Model: Moto Guzzi V85 TT Euro 5

Subject: Intake valve – Technical update

Campaign Code: PG2ZZQ2103_KIT_PGA

PHOTOS RELATIVE TO THE VALVE SEIZURE

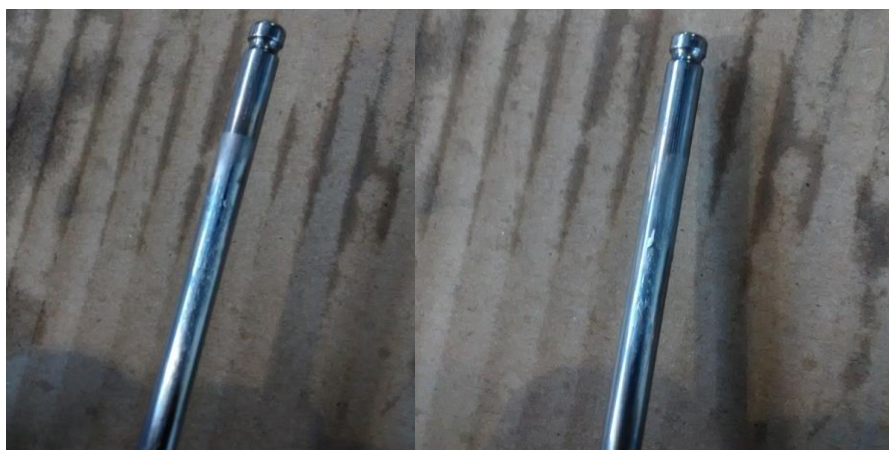
- Disassemble the head, release the intake valve and remove it from the head.
- Check for any signs of incipient seizure and adhesion by moving the valve without load inside the respective valve guide (see photos below).
- Only in the event that there are possible signs on the stem and/or traces of incipient seizure, replace the entire head in question.
- If, on the other hand, none of the above aspects have occurred, replace the intake valve only, without replacing the head.

By way of example, some photos are shown below in order to unequivocally identify possible incipient seizure of the valve stem in its seat, first and second photos, while in the third photo the adhesion, without load, of the valve stem in its seat is appreciable.
